Unimas Sportswear (Extension 2)

14 November 2024

2. Observations

Design report

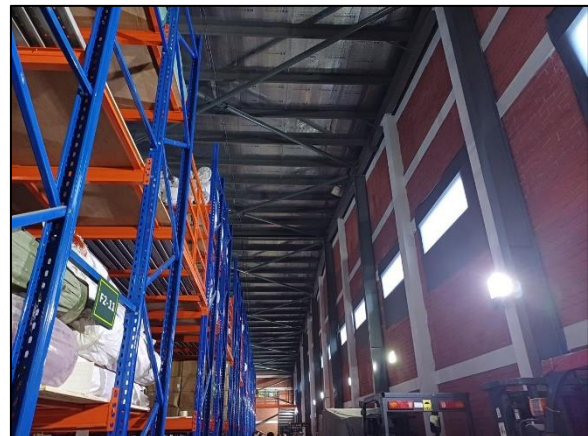
Observation-01: Prepared design report needs to be reviewed against lateral loadings (Warehouse Shed-1).

Description: During the inspection, an Engineering Assessment (EA) report was found onsite. No connection adequacy was included in the EA report. However, the building engineer is required to revise the prepared EA report based on as-built member sizes. Submit the revised EA documents to the RSC for detailed review against lateral forces.

Item No	Observation	Action Plan	Timeline
1.	Prepared design report needs to be reviewed against lateral loadings (Warehouse Shed-1).	The building engineer is required to revise the prepared EA report based on as-built member sizes. Submit the revised EA documents to the RSC for detailed review against lateral forces.	within 6 weeks

As built drawings

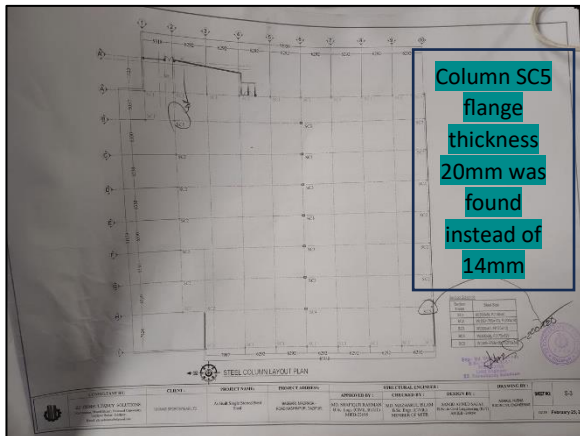
Observation-02: Discrepancy in as-built drawing (Warehouse Shed-1).

Description: During the inspection, mismatch was observed in the provided drawing with the as-built condition for the mentioned structures. Column SC5 mismatch was found with as-built drawings. The building engineer is required to survey the whole structure and update the drawing reflecting on-site condition.

2.		Carry out suggested remedial works if required.	within 6 months
3.	Discrepancy in as-built drawing (Warehouse Shed-1).	The building engineer is required to survey the whole structure and update the drawing reflecting on-site condition.	within 6 weeks

Loose cable bracing

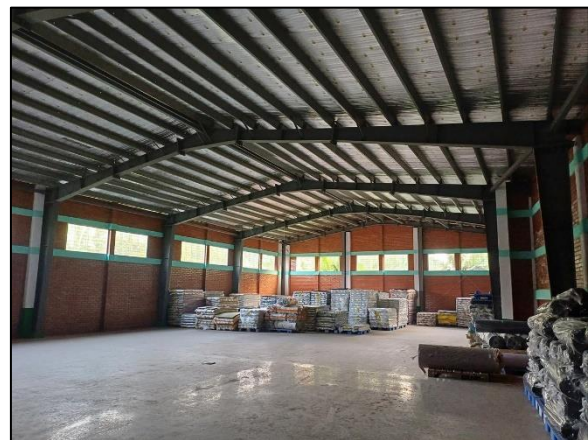
Observation-03: Loose cable bracing (Warehouse Shed-1).

Description: During the inspection, Loose cable bracing was found at the roof bracing. The factory is required to tighten the loose bracings for transferring the lateral loads properly.

4.	Loose cable bracing (Warehouse Shed-1).	The factory is required to tighten the loose bracings for transferring the lateral loads properly.	within 6 weeks

As built drawings

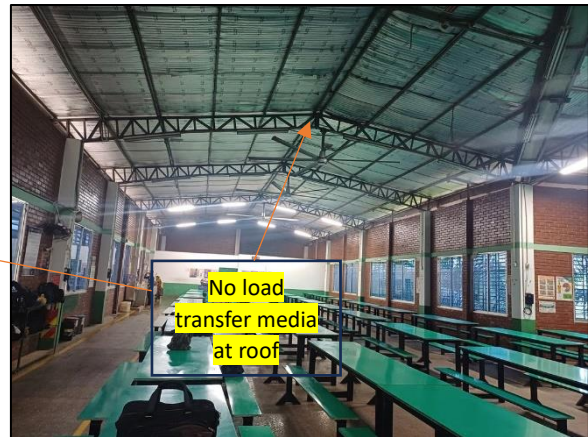
Observation-06: Discrepancy in as-built drawing (Warehouse Shed-2).

Description: During the inspection, mismatch was observed in the provided drawing with the as-built condition for the mentioned structures. Column SC2 mismatch was found with as-built drawings. The building engineer is required to survey the whole structure and update the drawing reflecting on-site condition.

7.		Carry out suggested remedial works if required.	within 6 months
8.	Discrepancy in as-built drawing (Warehouse Shed-2).	The building engineer is required to survey the whole structure and update the drawing reflecting on-site condition.	within 6 weeks

Lateral stability

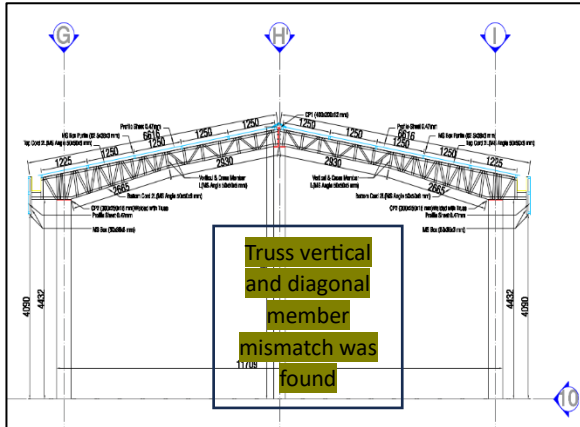
Observation-08: Incomplete lateral stability and absence of design report (Dining & Store Shed).

Description: Load transfer media is not provided along long direction for this shed. Therefore, the lateral stability system of the shed is incomplete. During inspection, no design report was available for this structure. The building engineer is required to check the lateral stability of the structure, prepare a design report and submit to RSC for detailed review against lateral forces.

10.	Incomplete lateral stability and absence of design report (Dining & Store Shed).	The building engineer is required to check the lateral stability of the structure, prepare a design report and submit to RSC for review.	within 6 weeks

Bolt missing

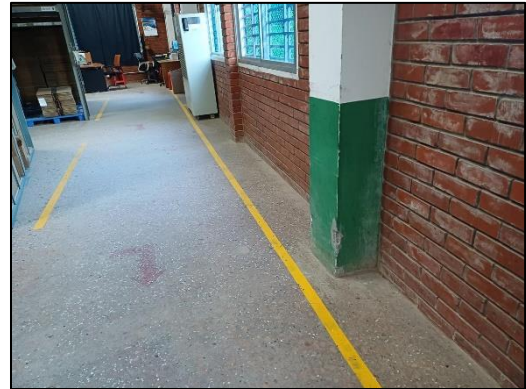
Observation 11: Missing nut-bolts at truss joint plate (Dining & Store Shed).

Description: Missing bolt was found at truss joint. The factory is required to install the missing bolts.

14.	Missing nut-bolts at truss joint plate (Dining & Store Shed).	The factory is required to install the missing bolts.	within 6 weeks
15.	Column susceptible to trolley impact (Dining & Store Shed).	Factory is required to provide guard for all exposed column to prevent from possible trolley impact.	within 6 weeks
16.	Unbraced storage racks on different floors (Dining & Store Shed).	The factory is required to provide anchorage/bracing to the storage racks to protect from falling hazard.	within 6 weeks

Columns are susceptible to trolley impact

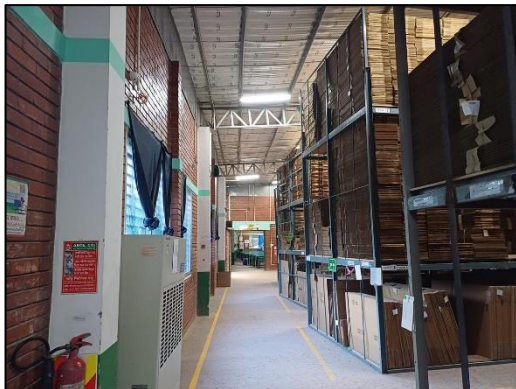
Observation 12: Column susceptible to trolley impact (Dining & Store Shed).

Description: Columns are susceptible to impact loading from trolly. Signs of damage in columns were observed. Factory is required to provide guard for all exposed column to prevent from possible trolly impact.
